**Optimization Review
Palermo Wellfield Superfund Site**

City of Tumwater, Thurston County, Washington

Report of the Optimization Review
Site Visit Conducted at the Palermo Wellfield Superfund Site on
August 25, 2011

December 14, 2011

**Figure 2-4
Palermo Wellfield LTM
Piezometric Contour Map with
TCE Concentrations in Groundwater
October 2010**

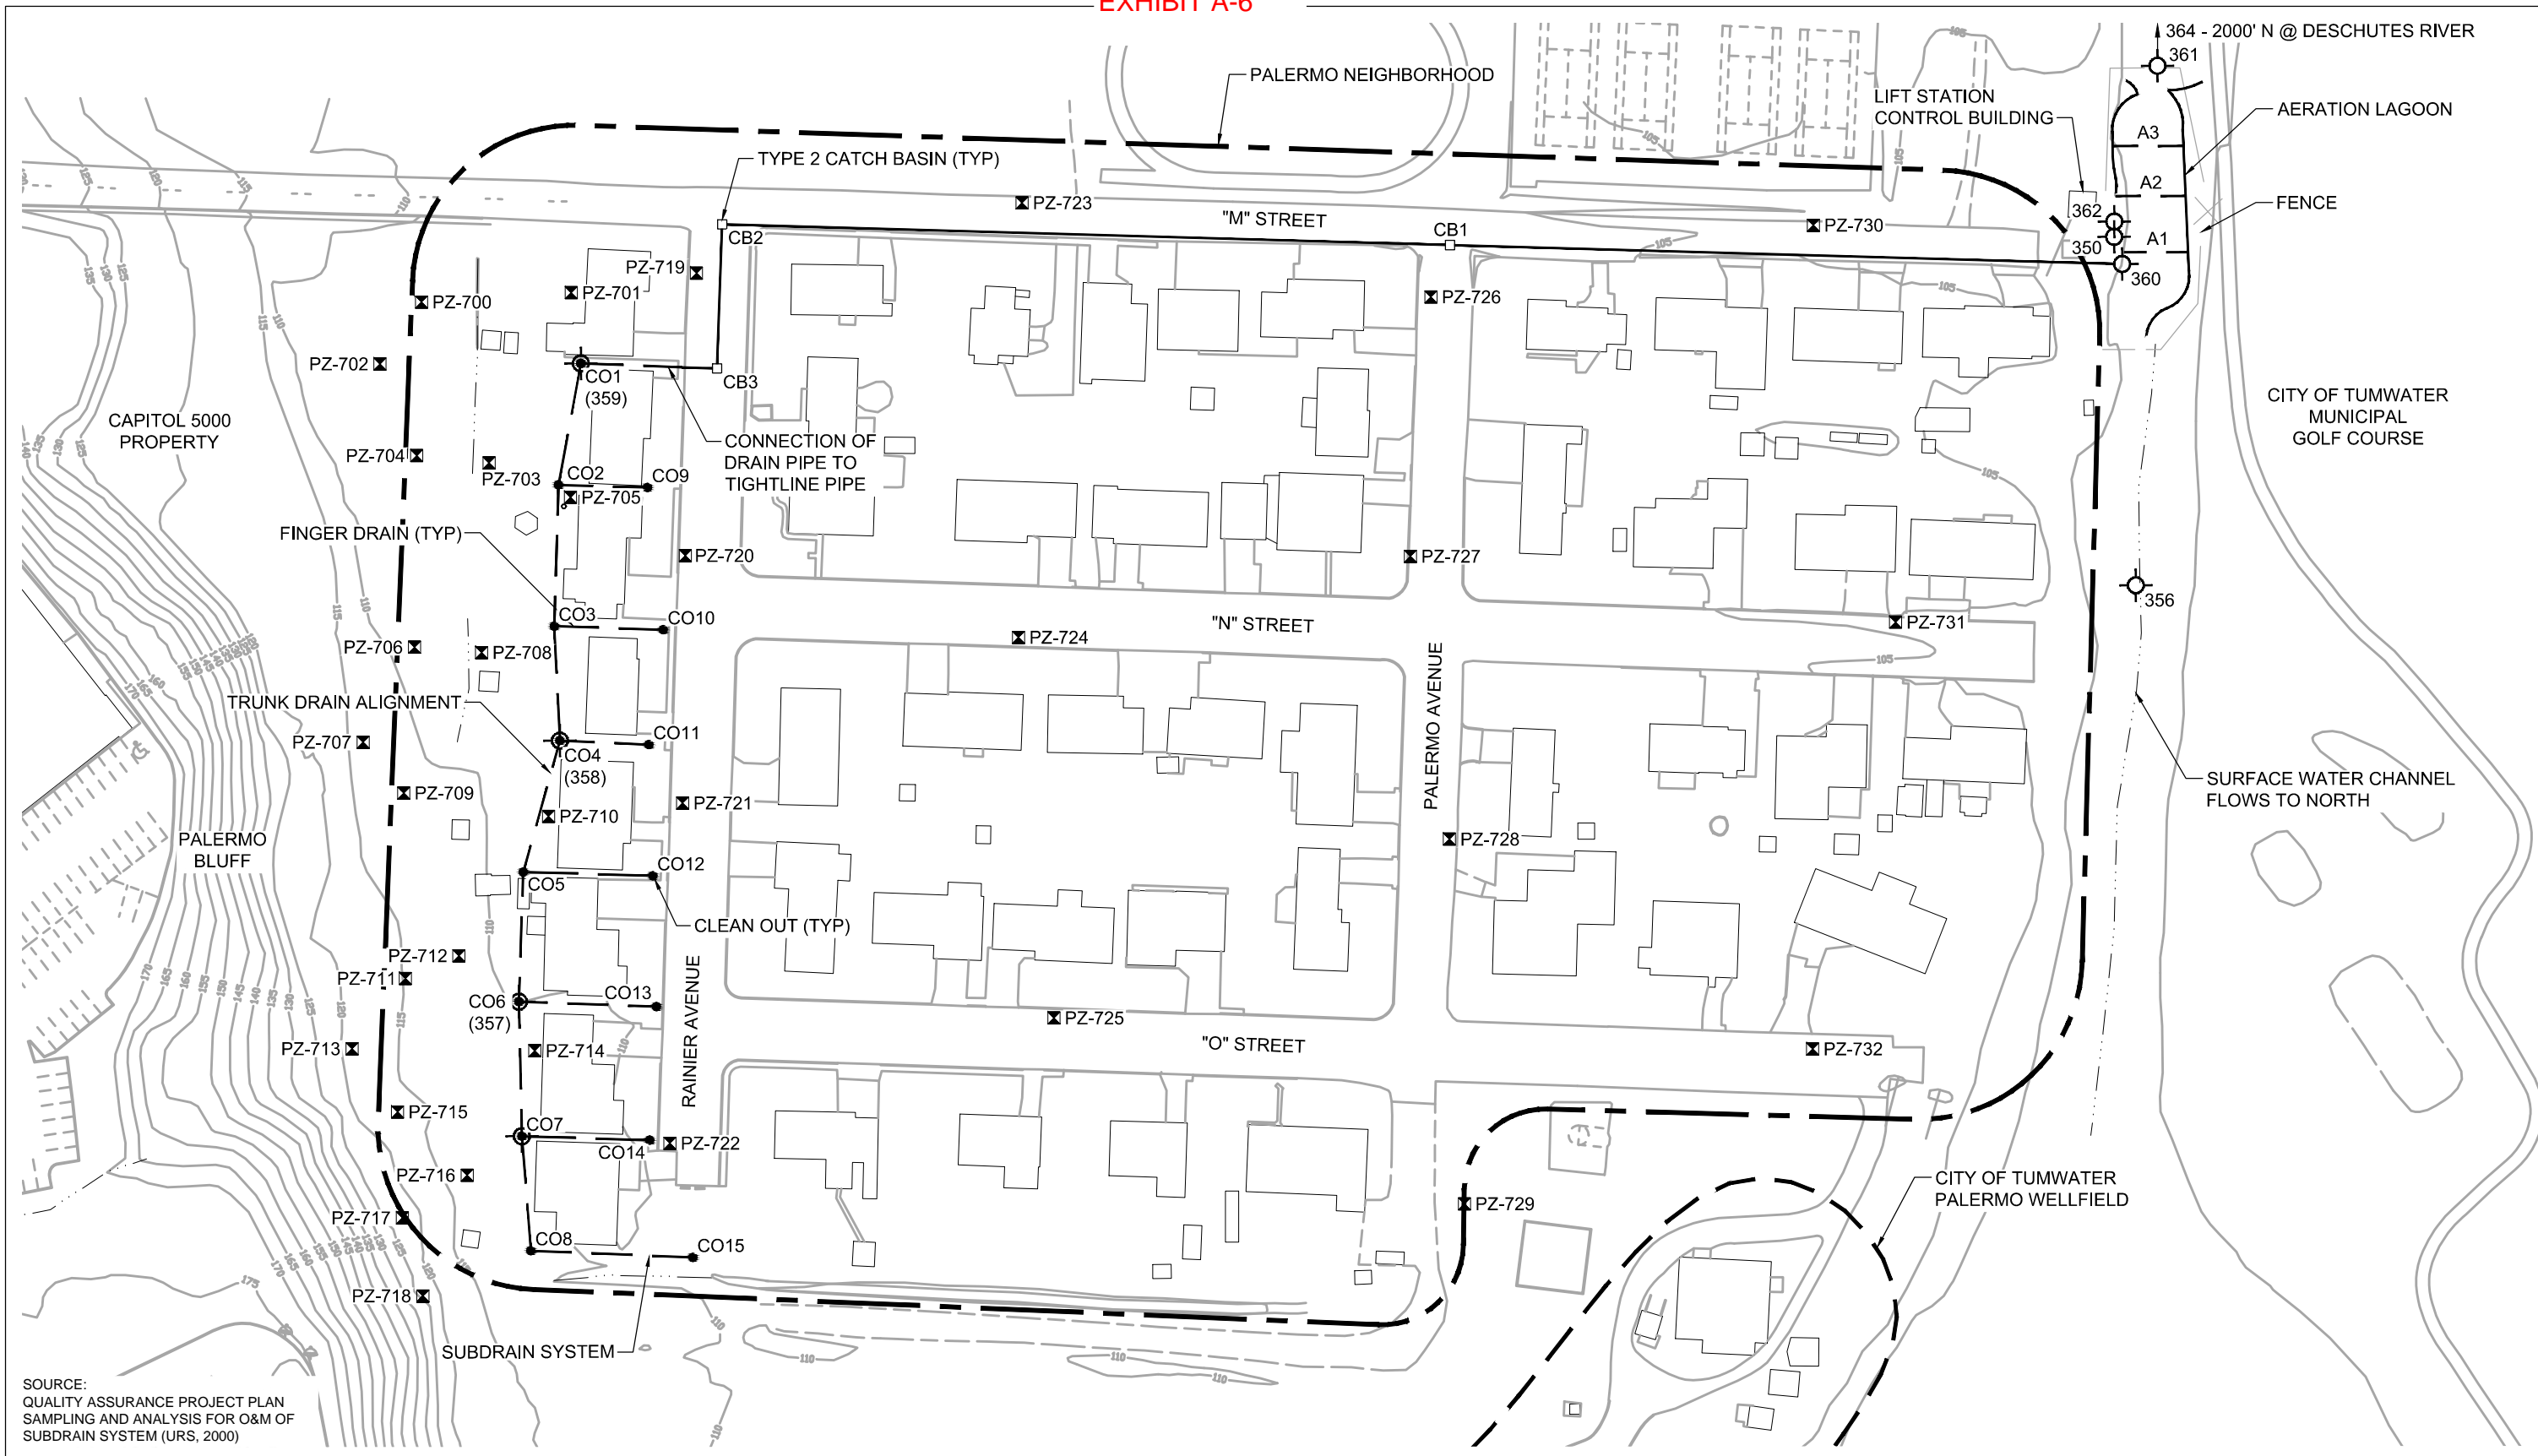
For purposes of this evaluation, it is assumed that the target capture zone is the TCE plume greater than 5 $\mu\text{g/L}$. The width (w) of the target capture zone is approximately 800 ft as measured from the figure in Attachment A.

Using this same figure, the hydraulic gradient in the valley is estimated to be 0.03 (10 ft head drop over approximately 330 ft distance) in the valley.

FIGURE 1
 CROSS SECTION ILLUSTRATION OF SITE CONCEPTUAL MODEL
 Palermo Wellfield Superfund Site

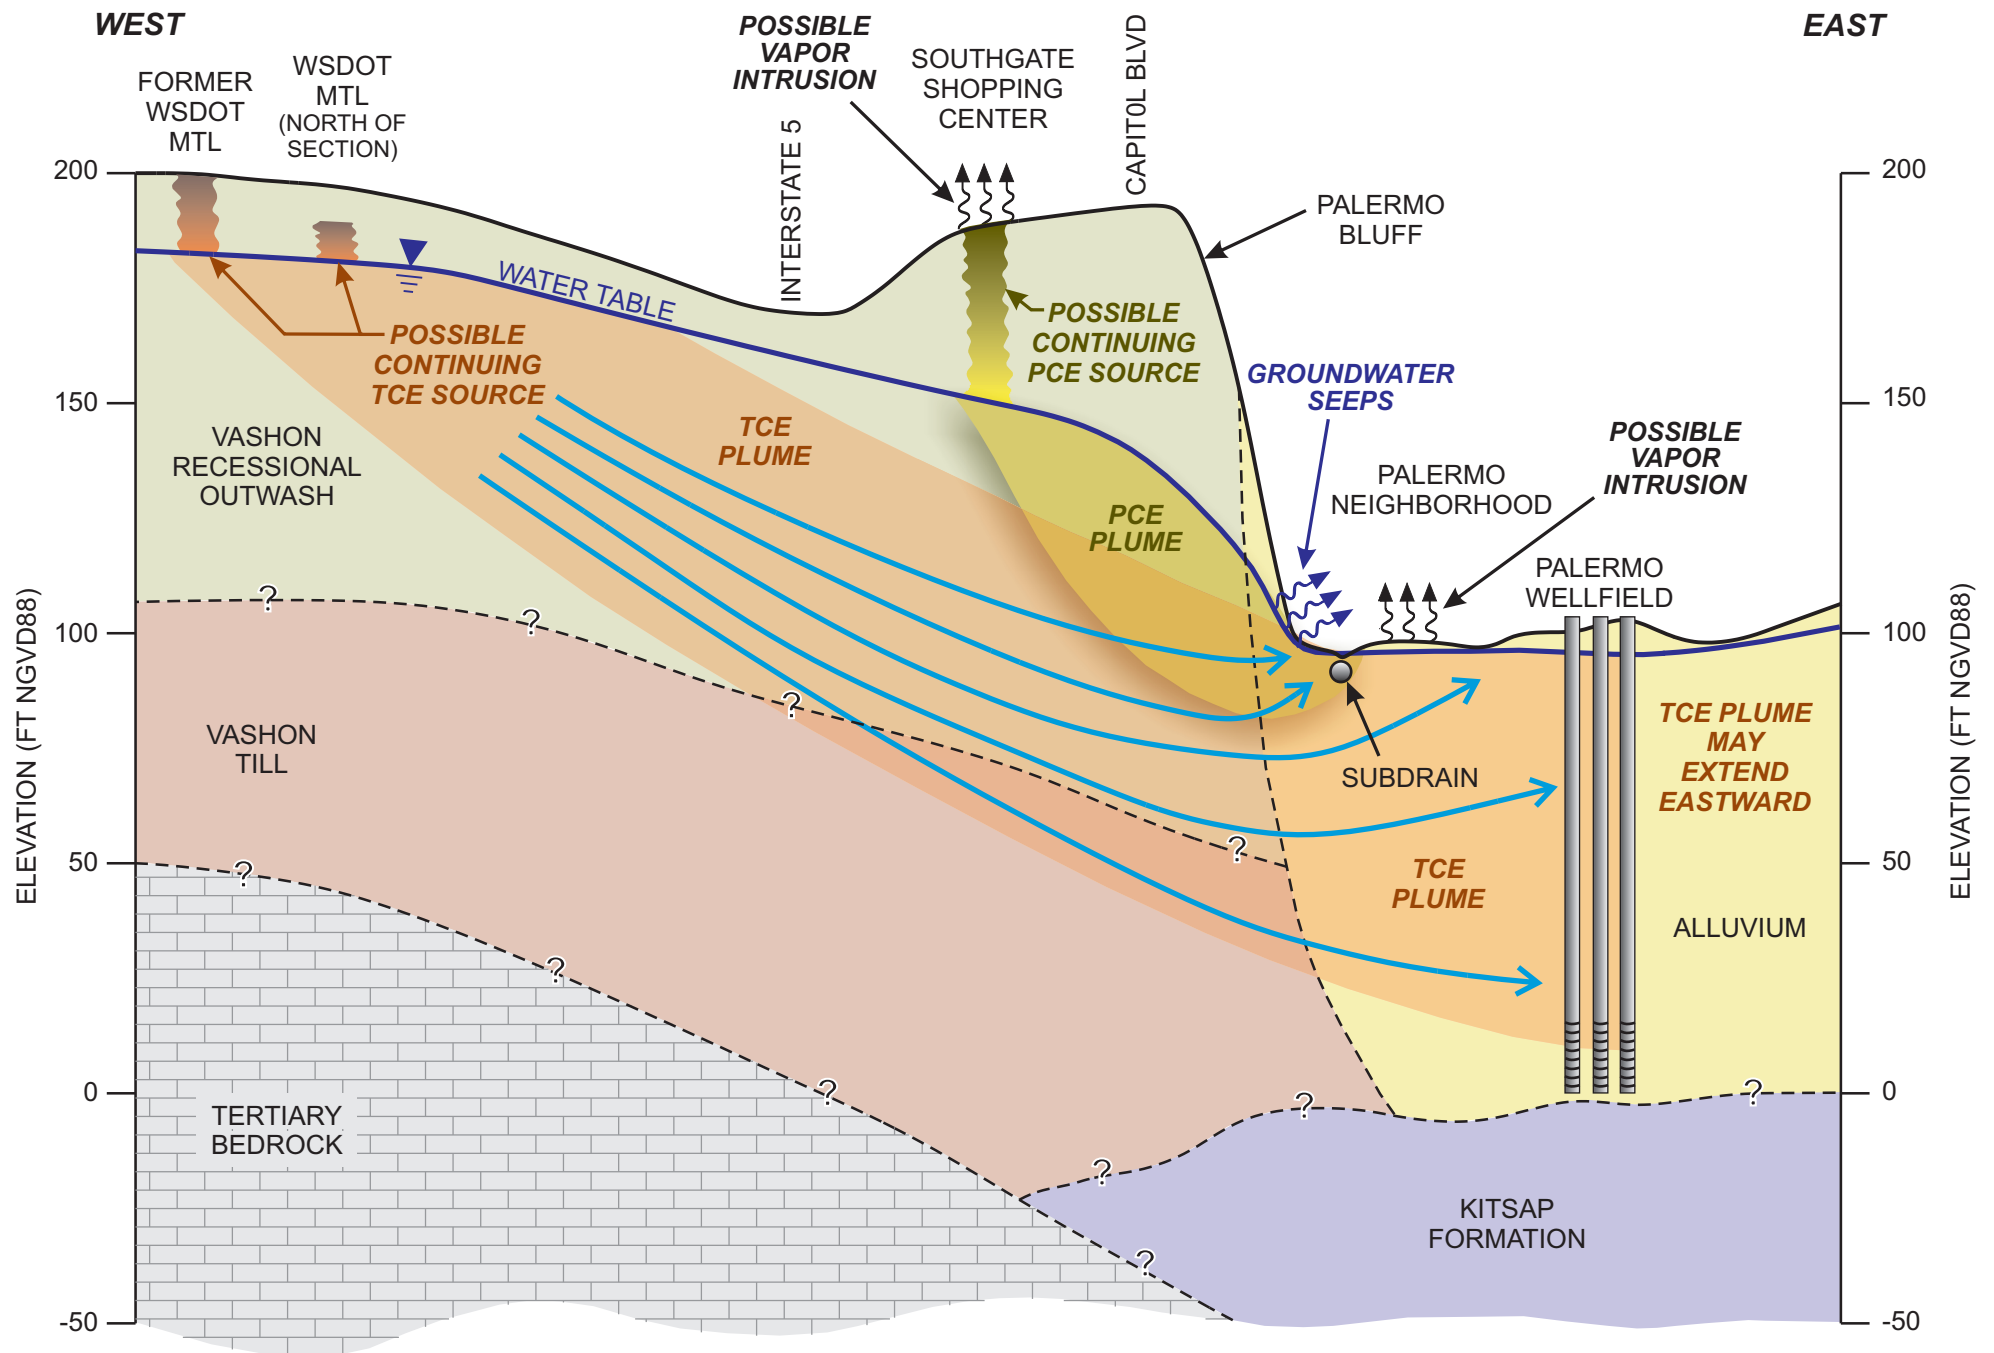
Figure 1 is a cross-section illustration that summarizes the CSM. Volatile organic compound (VOC) contamination released at the surface and/or in the shallow subsurface from the Southgate Dry Cleaners and both the current and former WSDOT MTL facilities has impacted groundwater at the Site. The soils are relatively permeable (described as sands) and low in organic carbon. In addition, the releases in some cases may have occurred approximately 25 years before remedial investigation (RI) sampling occurred. These factors contributed to relatively low soil concentrations observed during the RI and may have resulted in relatively weak continuing sources of dissolved groundwater contamination in 2010 at these previously identified sources. The relatively high groundwater flow rates and low organic carbon have contributed to contaminant flushing over the period of three to four decades from the time of the original releases until present. As a result, the majority of contamination associated with the original releases appears to have migrated away from the source areas and is now present in the vicinity of the Palermo neighborhood. However, one or more of the historic source areas may be continuing to impact groundwater.

The known extent of the VOC groundwater plume is approximately 3,000 ft long and includes the Palermo Wellfield. The fate of contaminated groundwater includes surface expression as seeps in the vicinity of the Palermo neighborhood, capture by the subdrain system (constructed as a French drain), extraction by the Palermo Wellfield, or potentially migration beyond the Palermo neighborhood and Palermo Wellfield. Contaminant migration pathways begin at the water table near the source areas and gradually migrate deeper as a result of regional pumping and recharge. Due to the relatively eastern location of the main PCE source area (Southgate Dry Cleaners), it is likely that the PCE has remained sufficiently shallow to be captured by the subdrain system as reflected by the PCE concentrations in the subdrain and the absence of PCE detections in groundwater downgradient of the subdrain. PCE concentrations have been decreasing in the subdrain because the PCE source was mostly removed and the PCE is being flushed from the aquifer. TCE contamination, which started migrating from sources further west, has had the opportunity to migrate slightly deeper and is more dispersed. The TCE plume core likely migrates under the subdrain. The removal of water from the subdrain and the surface expression of seeps due to the abrupt change in regional topography result in an upward gradient in the valley such that some of the deeper TCE migrates closer to the surface in the Palermo neighborhood and some is extracted by the Palermo Wellfield. Shallow groundwater contaminated with TCE and PCE and/or shallow groundwater discharging to the surface represent potential vapor intrusion (VI) exposures for residents in the Palermo neighborhood north of the Palermo Wellfield.

Figure 1 is a cross-section illustration of the CSM as interpreted by the optimization team.

The CSM as presented by the optimization team suggests that the majority of contaminant mass may have already migrated from the source areas due to high natural groundwater flushing rates and that relatively weak residual sources are contributing a low flux of contamination to groundwater. This CSM is generally supported by decreasing TCE concentration trends in many upland monitoring wells (e.g., MW-109, MW-111, MW-ES-03, and MW-ES-05) and low-level fluctuating concentrations near the former WSDOT MTL (e.g., MW-UI and MW-ES-07). The declines to date are the result of decades of groundwater flushing in the absence of a strong continuing source. Using a K of approximately 10 ft per day (consistent with RI modeling assumptions), a hydraulic gradient of 0.03 ft per foot (measured), and an effective porosity of approximately 0.25 (reasonable assumption), the groundwater seepage velocity is over 400 ft per year, allowing for approximately 5 pore volumes of flushing of the 3,000-foot long plume over a 30 to 40 year period (e.g., from approximately 1970 to approximately 2010).
